3710 Mitchell Street  
Kensington Historic District

RE: Easement Committee Review  
Kensington Armory  
Montgomery

Address: 3710 Mitchell Street	Meeting Date: 12/07/94
Resource: Kensington Historic District	Review: HAWP/alteration
Case Number: 31/6-94M	Tax Credit: No
Public Notice: 11/23/94	Report Date: 12/1/94
Applicant: Town of Kensington	Staff: David Berg
PROPOSAL: Alterations to accommodate HVAC	RECOMMEND: <b>APPROVE</b>

**KENSINGTON COMMUNITY CENTER  
H.V.A.C. RETRO-FIT DESIGN**

EAST ELEVATION - NEW WORK

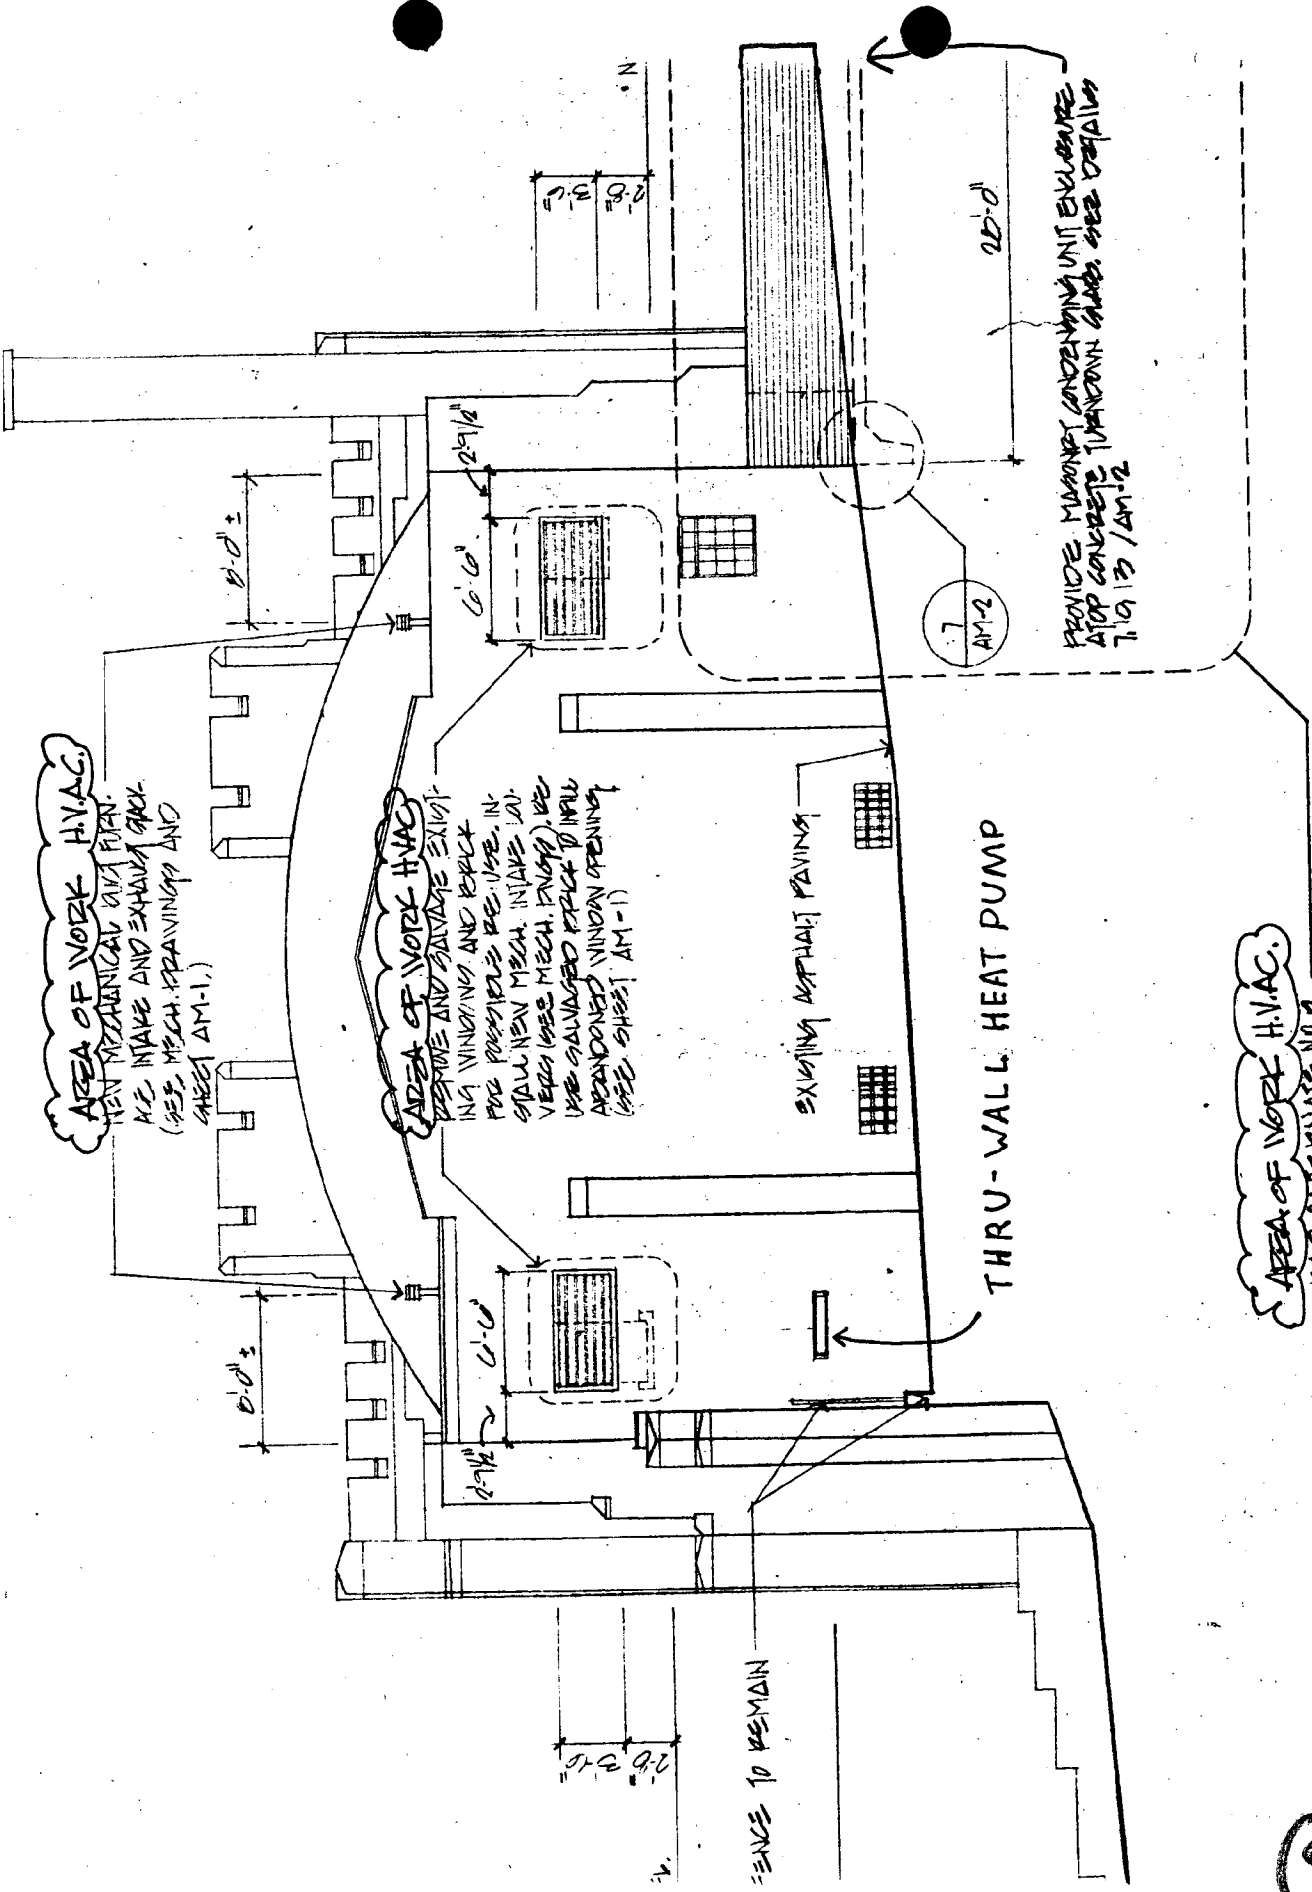
- 1) Screening for rear condenser unit:

A large condenser unit will be placed at the southeast corner of the building. The applicant proposes to surround this unit with a 6' high brick wall with a precast concrete cap. The wall will be constructed of brick matching the existing structure's brick as closely as possible. The precast cap will match the existing cap on the front entry terrace at the North Elevation. Staff finds the design and placement of the brick wall to be compatible with the historic resource.

South Elevation

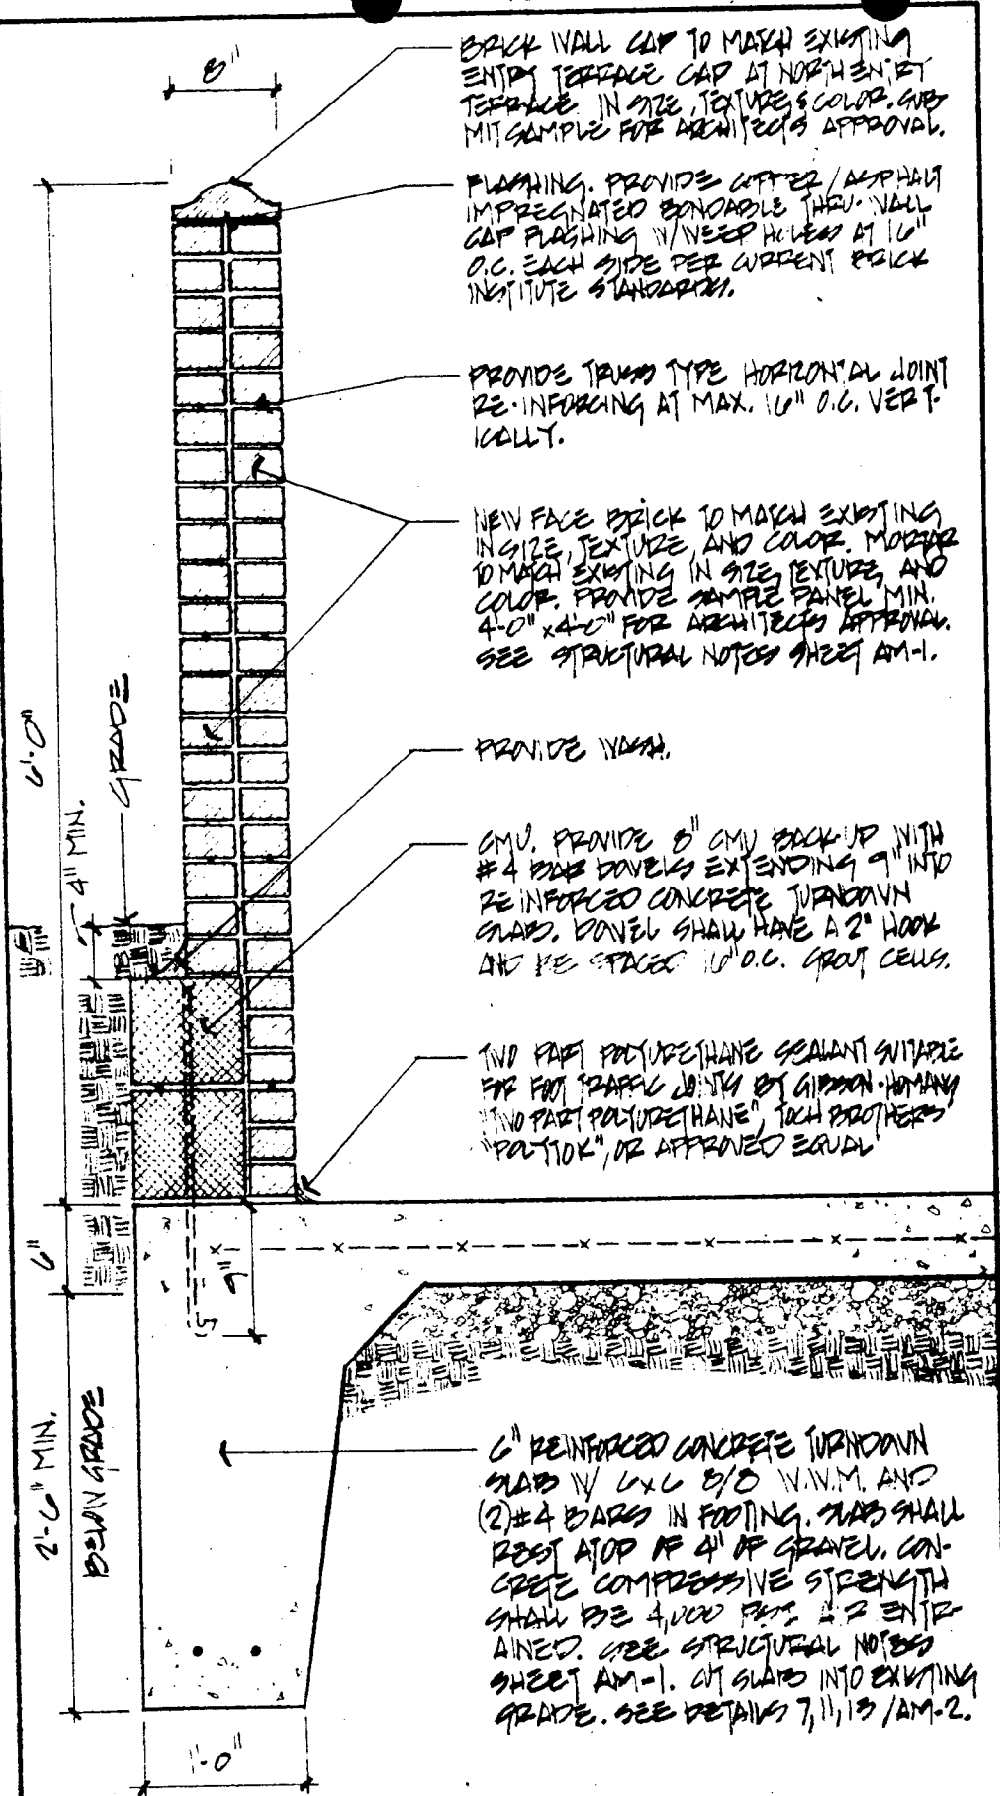
Two furnace flues are proposed for the rear (South Elevation) roof. The flues will be installed on the flat sections of this roof, making them less visible from the ground. Staff feels that this is the most compatible placement of the flue stacks.

Two fresh air intake louvers will be placed at the rear (South Elevation) of the building replacing two original windows. Although Staff does not consider the removal of original windows desirable, Staff feels that the proposed location for the louvers is acceptable. The applicants will attempt to save the windows for possible future reuse and will also attempt to reuse any removed bricks when installing the louvers.

A small heat pump will be installed on the left rear (South Elevation) of the structure centered directly below the proposed left air intake louver. The unit will measure 3' 6" in length and 1' 4" tall. It will be at the first floor level and will be below the fence height. Since the unit is relatively small and will not be visible from the streetscape, staff recommends approval of the installation.
